Newtex Knit Fashion Ltd. (Extension)

11 January 2024

1. Building Information

Observation-03 Improper connection and bolt missing. (Building-2).

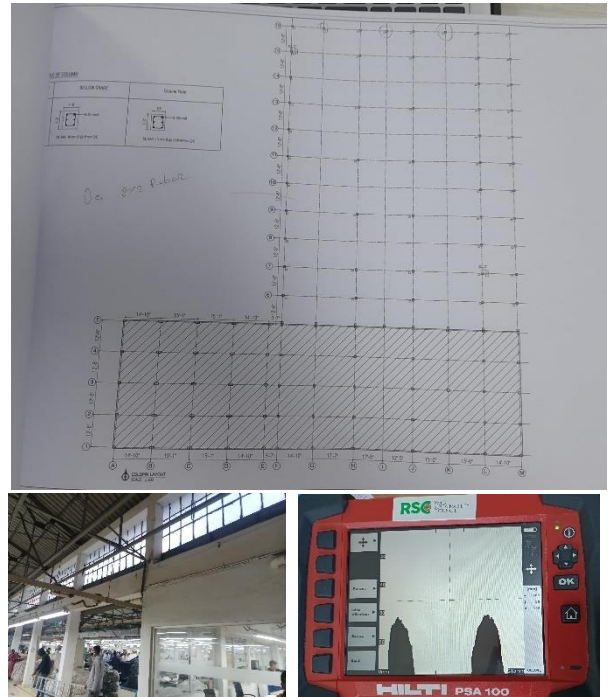
Description: Improper connection between steel beam and RC column was found in some locations. Also, bolt missing was found. The building engineer is required to check the connection and suggest proper remedial measures accordingly. Also install the missing bolts.

Observation-04: Non-structural elements not anchored or braced. (Building-2)

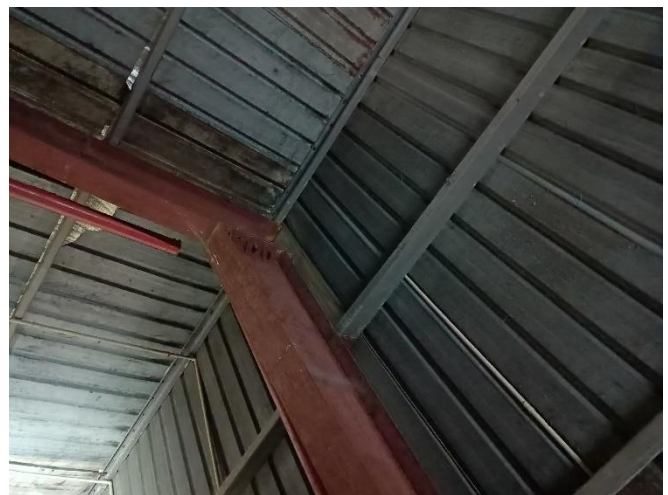
Description: Some racks on floors are not anchored or braced to resist lateral (earthquake) forces. The factory is required to anchor/brace all non-structural elements adequately to resist earthquake forces.

Observation-07: Mismatches in as-built drawings. (Building 04).

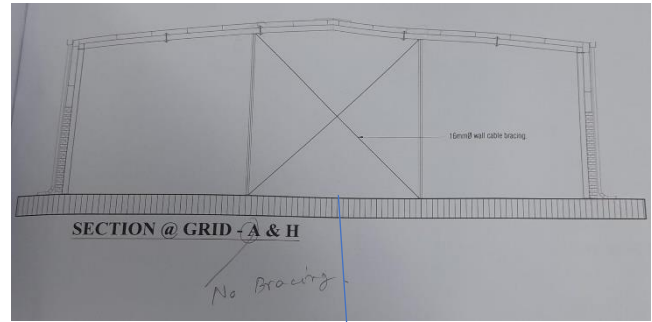
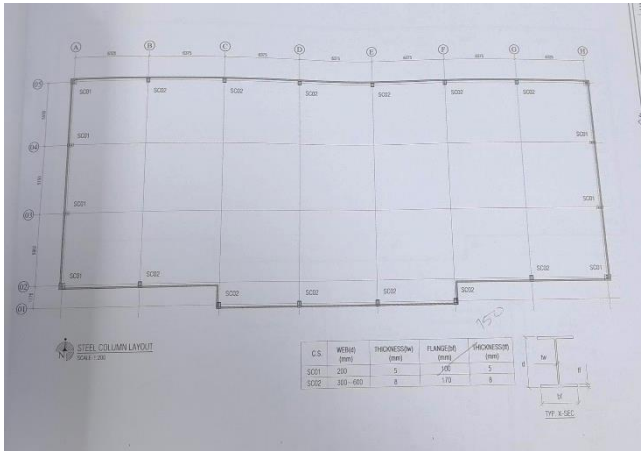
Description: Flange width of SC1 column was measured 150 mm instead of 100 mm. Also, cable bracing was found in grid-A as per drawings.

Observation-08: Incomplete lateral stability system. (Building-04).

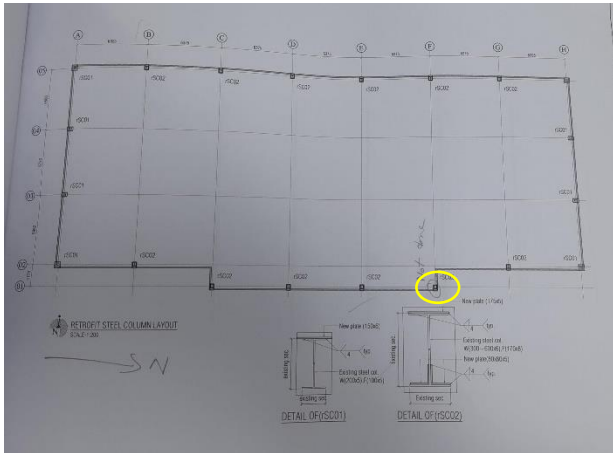
Description: No compression strut was found along the long direction. Only cable bracings were found onsite. So lateral stability in the long direction is incomplete. The building engineer is required to check the stability system of the existing structure.

Observation-10: Non-structural elements not anchored or braced. (Building 04).

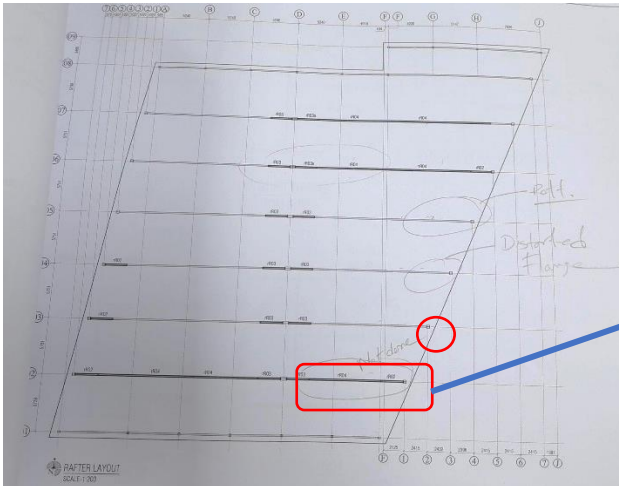
Description: Some racks on floors are not anchored or braced to resist lateral (earthquake) forces. The factory is required to anchor/brace all non-structural elements adequately to resist earthquake forces.

Observation-11: Incomplete retrofitting work. (Building-05).

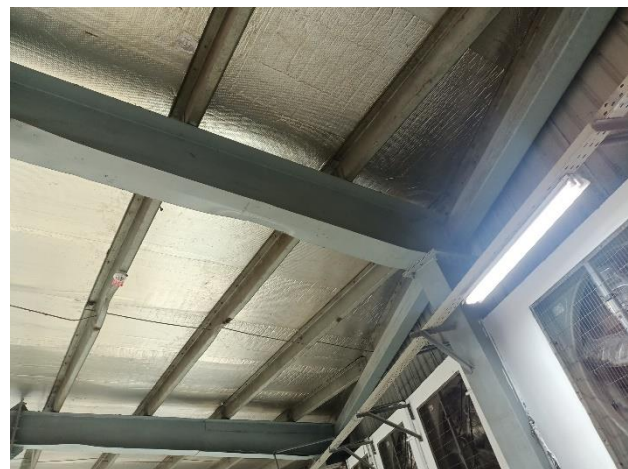
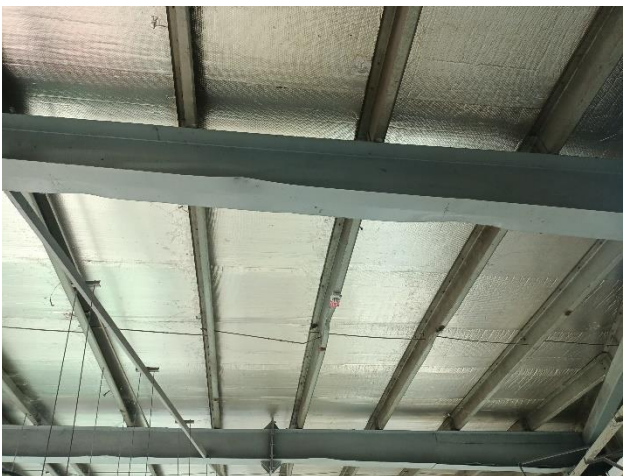
Description: Retrofitting work for rSC3a column and rafter (marked in red) have not been done. All required retrofitting work need to be carried out as per EA report after reviewed by RSC.

Incomplete retrofitting work. (Building-05).	EA report needs to be reviewed against lateral loading by RSC.	within 6 weeks
	All required retrofitting work need to be carried out as per EA report after reviewed by RSC.	within 6 months

Observation-12: Distorted flange of rafter. (Building 05).

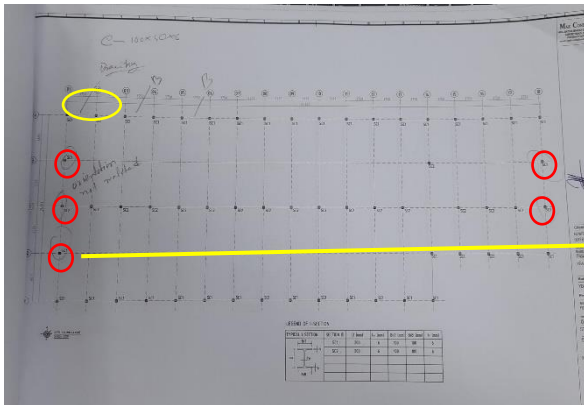
Description: A distorted steel flange was found in the rafter. Building engineer is required to check stability and serviceability of the distorted flange and suggest suitable remedial method.

Distorted flange of rafter. (Building 05).	Building engineer is required to check stability and serviceability of the distorted flange and suggest suitable remedial method.	within 6 weeks
	Implement remediation work.	within 6 months
Mismatches in as-built drawings. (Building 06).	The building engineer is required to survey the full structure and produce accurate as-built drawings.	within 6 weeks
Incomplete lateral stability system. (Building 06)	The building engineer is required to check the stability system of the existing structure.	within 6 weeks
	Implement remediation work if required.	within 6 months
Non-structural elements not anchored or braced. (Building 06)	The factory is required to anchor/brace all non-structural elements adequately to resist earthquake forces.	within 6 weeks

Observation-14: Incomplete lateral stability system. (Building 06)

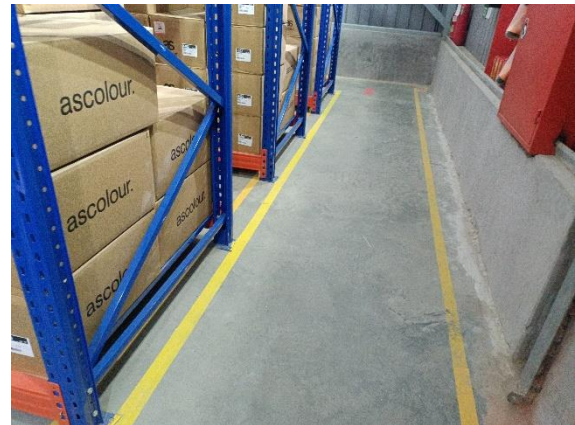
Description: No compression strut was found along the long direction. Only cable bracings were found onsite. So lateral stability in the long direction is incomplete. The building engineer is required to check the stability system of the existing structure.
